# UNITED STATES PATENT AND TRADEMARK OFFICE

APPLICATION NO.	FILING DATE	FIRST NAMED INVENTOR	ATTORNEY DOCKET NO.	CONFIRMATION NO.
10/662,888	09/15/2003	Jacques Billet	4384-000011	1167
27572	7590	06/23/2005	EXAMINER	
HARNESS, DICKEY & PIERCE, P.L.C. P.O. BOX 828 BLOOMFIELD HILLS, MI 48303			CHAN, KO HUNG	
			ART UNIT	PAPER NUMBER
			3632

<b>Office Action Summary</b>	Application No.	Applicant(s)
	10/662,888	BILLET, JACQUES
	Examiner	Art Unit
	Korie H. Chan	3632

## DETAILED ACTION

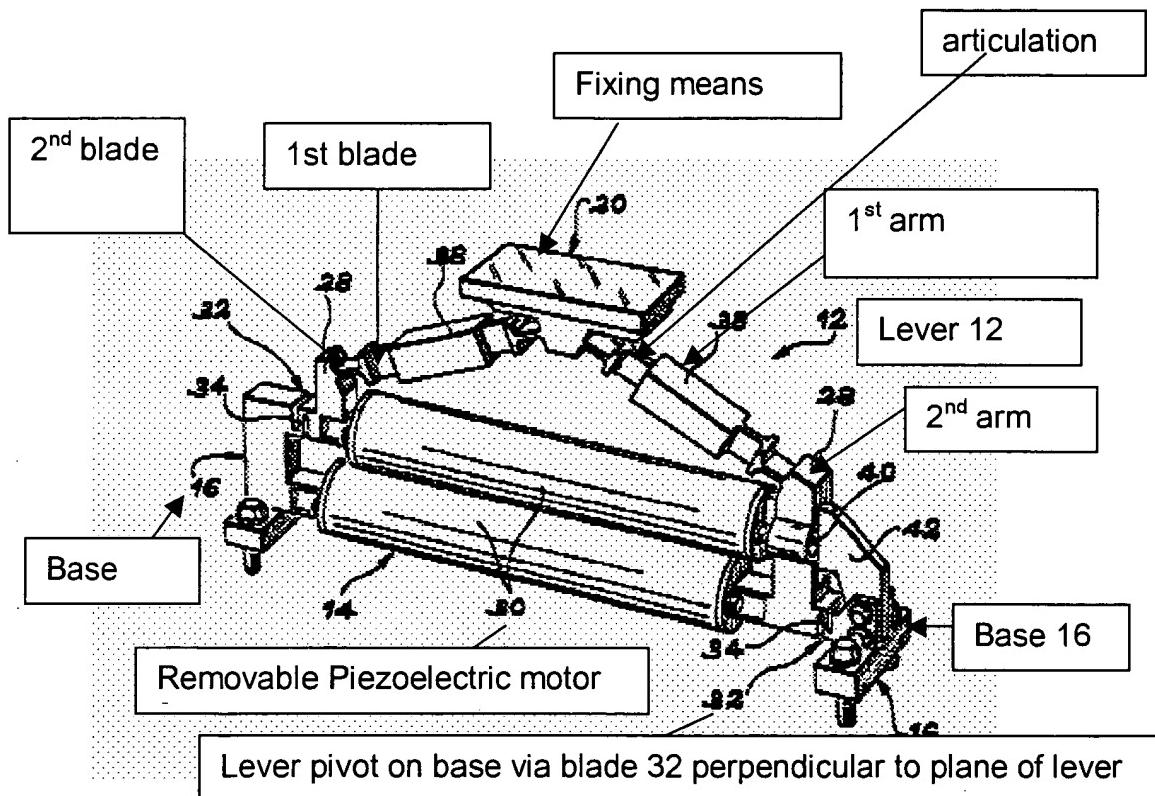
Claims 1-19 stand rejected under 35 U.S.C. 102(b) as being anticipated by Bailly et al (French patent no. FR 2,773,890). Bailly et al disclosed all the claimed features of applicant's invention (see figure 3 embodiment below).

Also, Bailly discloses three devices (fig. 1) spaced 120 degrees apart (page 10, line 12). Bailly discloses a flexible blade member (32) connected between the base (16) and the second arm (28).

Applicant's arguments filed March 28, 2005 have been fully considered but they are not persuasive. Applicant's amended claims have not overcome the rejection under Bailly. Thus, claims 1-19 stand rejected under Bailly. Bailly does disclose a flexible blade member (32) connected between the base (16) and the second arm (28).
